PLAN COMMISSION REPORT

Item No. **5A**

Proposal: Building, Site, & Operation Plan Review

Description: Review of a request to approve a building, site, and operation plan for the construction and utilization of a $\pm 8,060$ square foot industrial building for the property located directly north of 4005 Quick Drive.

**PROPOSED
SITE PLAN**

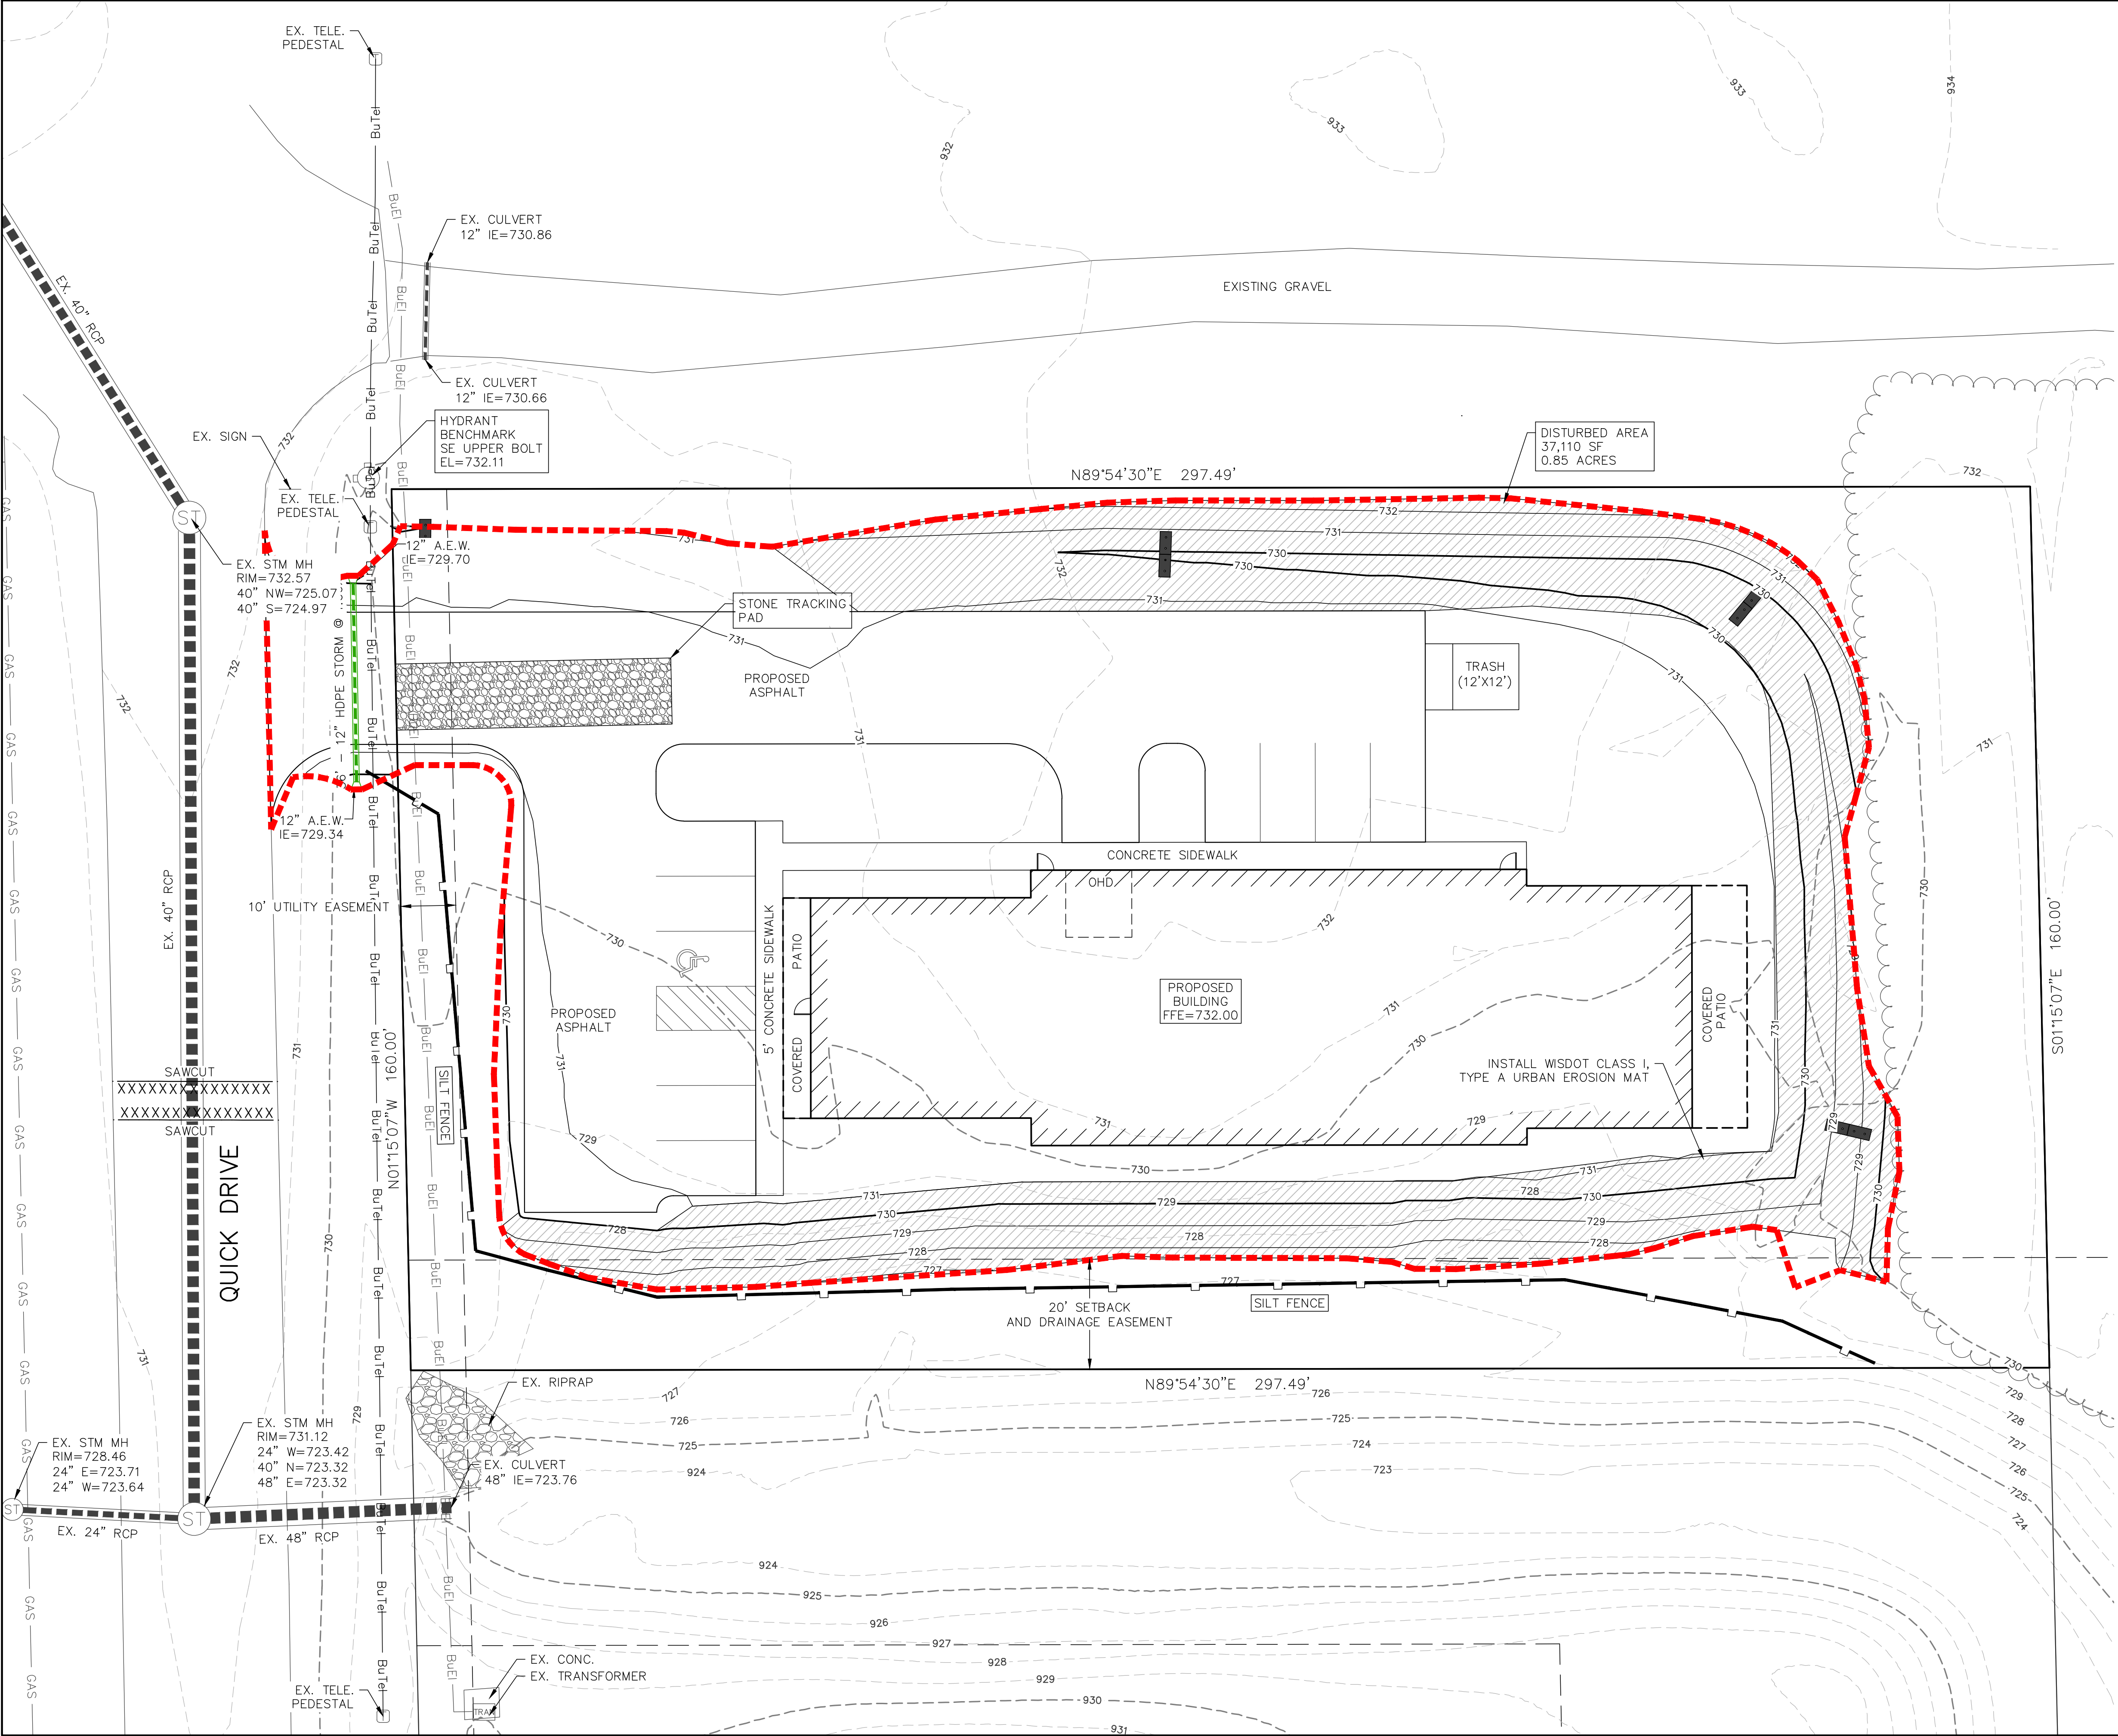
A dumpster is proposed on the north side of the building, enclosed with cedar planks. Staff recommends adding vegetative screening around the enclosure to reduce visual impact.

To better screen the overhead door from Storage Drive, staff suggests additional plantings along the northwest lot line as stated earlier in this report.

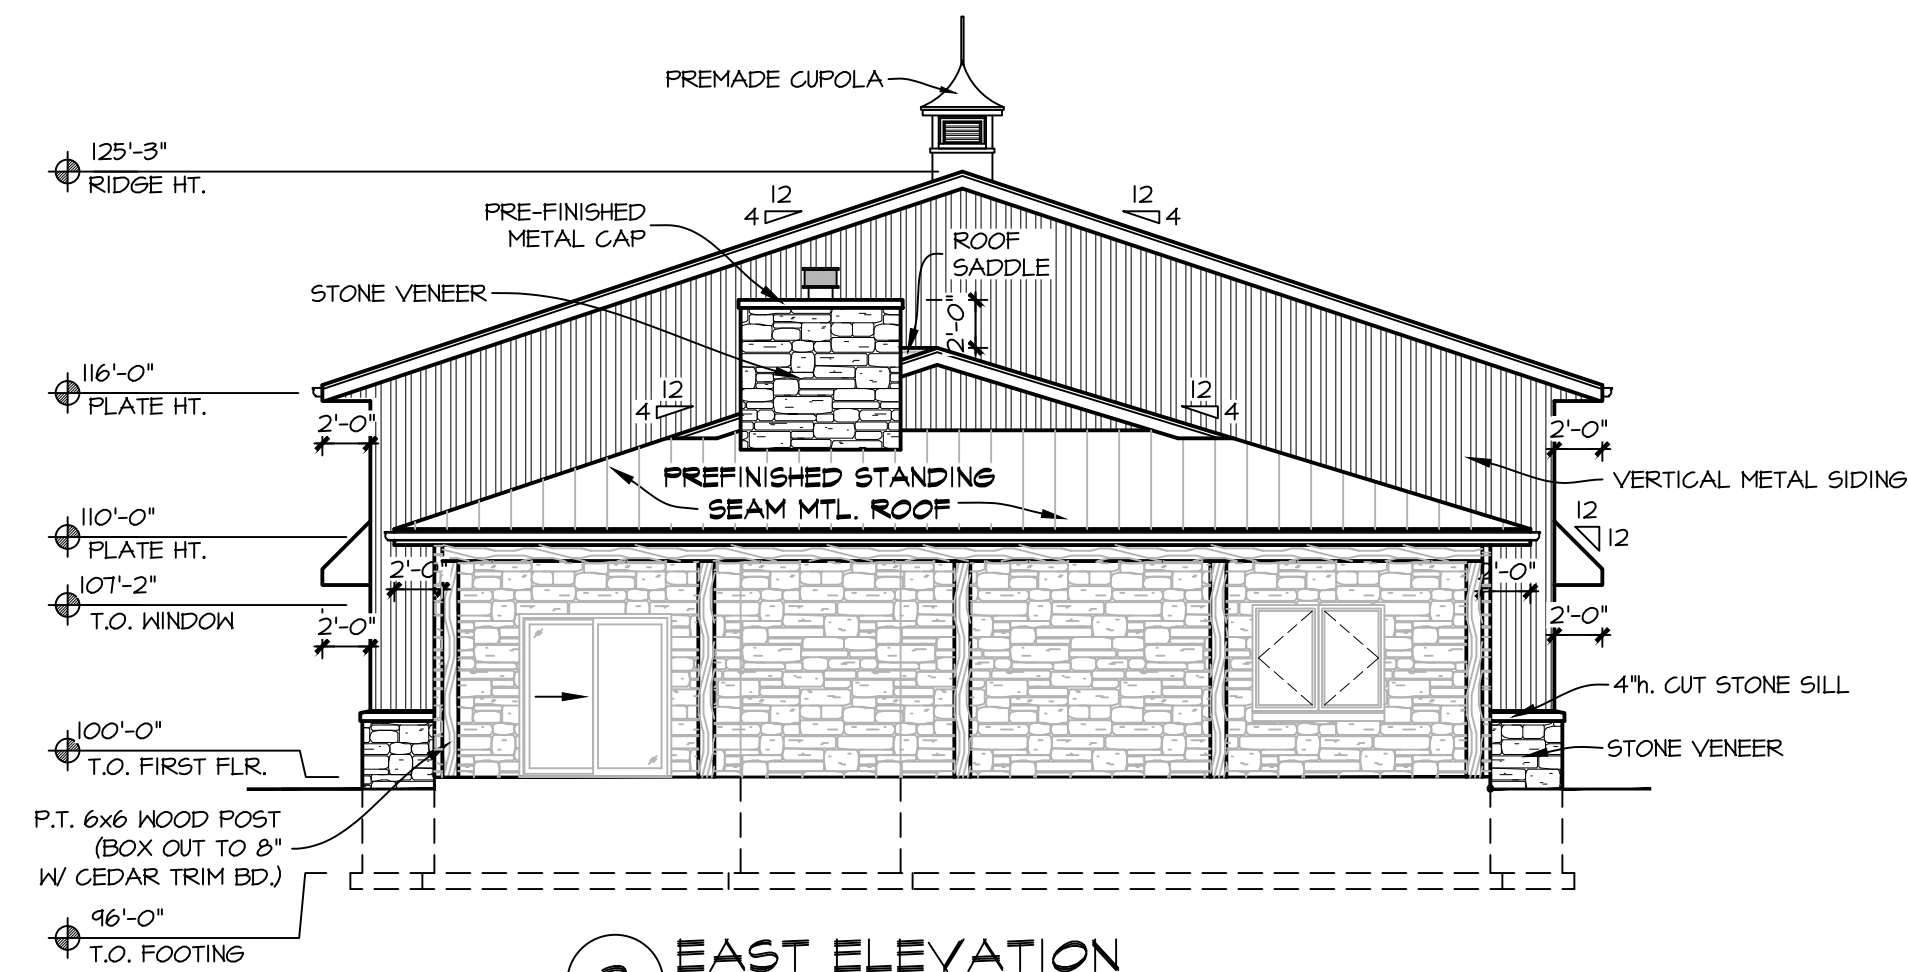
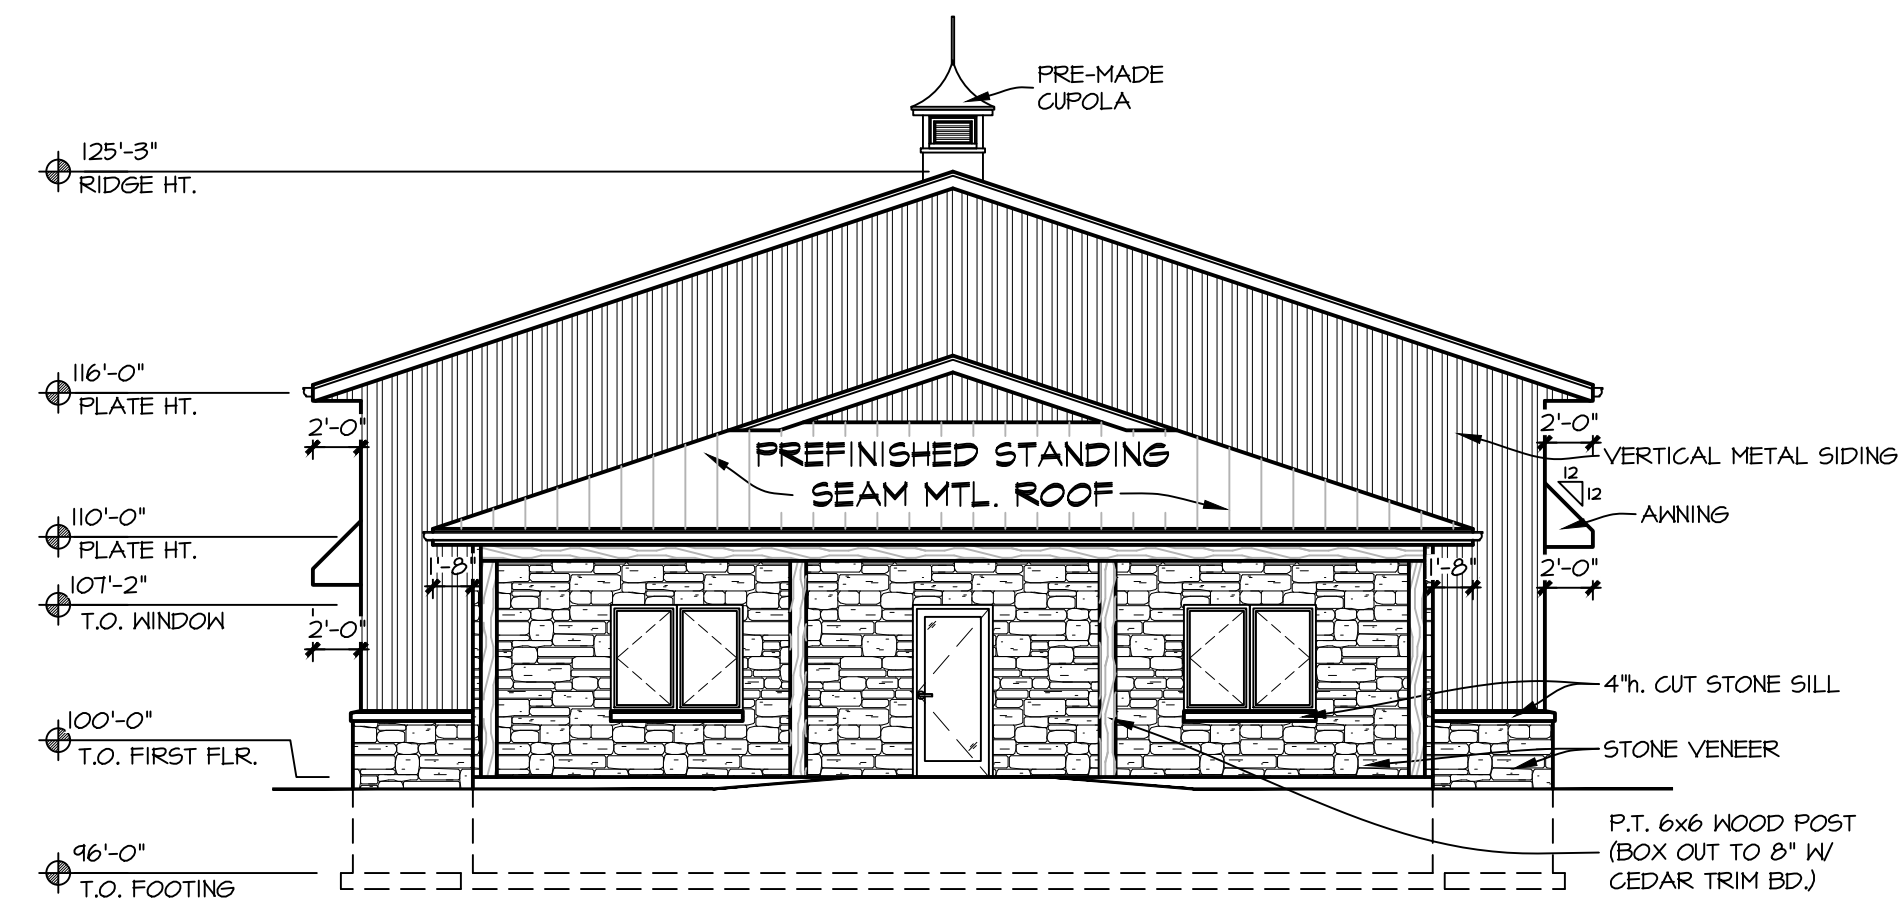
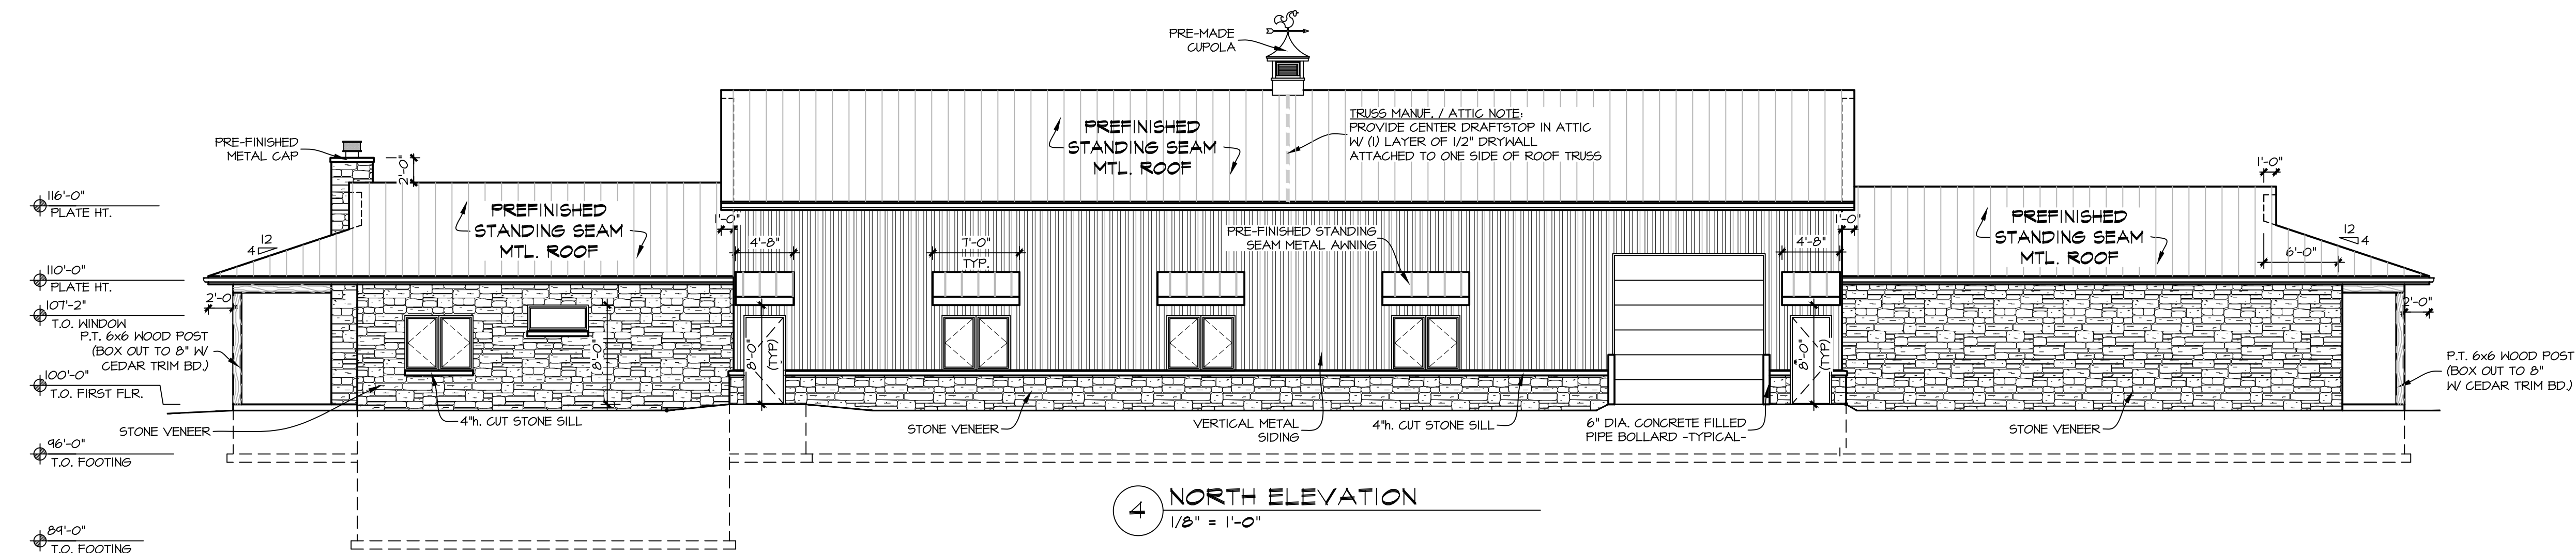
The building will feature metal panel siding with a masonry base on all sides. The revised plans show that the east and west elevations will consist primarily of masonry, as recommended by staff in previous review. However, even with this enhancement, the design does not meet zoning requirements that mandate 75% of the visible building perimeter be clad in acceptable exterior materials—metal is not considered a qualifying material under code. A $\frac{3}{4}$ majority vote of the Plan Commission is required to approve the proposed metal exterior.

The north elevation includes one overhead door not facing a public road. Per design standards, loading areas, service entries, and mechanical equipment must be screened or attractively designed to minimize visual impact. Screening options include densely planted trees or shrubs, opaque fencing, and/or garden walls at least 7 feet tall (plant material must reach 7 feet within 2 years). Staff recommends additional screening be installed on the northwestern portion of the site to minimize visual impact of the overhead door.
